Amendments to the proposal to develop Phase II of gtr No. 7
and to establish an informal group for its development

Gtr No. 7 (Head restraints)

The text reproduced below was submitted by the representative of the United States of America and proposes amendments to the proposal to develop amendments to global technical regulation (gtr) No. 7 (ECE/TRANS/WP.29/AC.3/25). The proposed amendments are marked in bold and in strikethrough characters.

Whiplash Injuries in Japan (GTR7-02-16e, pg 6)

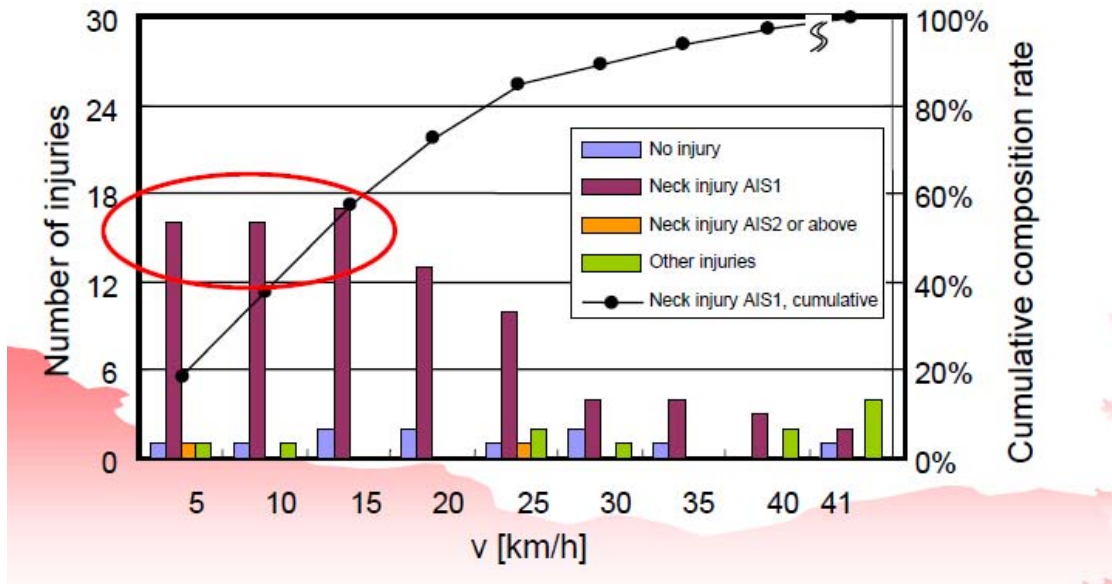
A deeper review of United States of America's (USA) initial data shows that while there are a significant number of AIS 2 and AIS 3 injuries occurring in rear impact crashes greater than 18 km/h, most of the neck injuries, which can be evaluated by rear impact dummies, are AIS 1 and AIS 2. For AIS 1 injuries, there are approximately an equal number of occurrences below 18 km/h as there are above 18 km/h. Research from Japan shows similar trends, with a significant number of injuries occurring in the range of 15 – 25 km/h.

An evaluation of research titled “Recommendations for a Low-speed Rear Impact Sled Test Pulse” conducted by the EEVC concluded that most long term whiplash injuries are sustained at speeds between 16 km/h and 25 km/h.
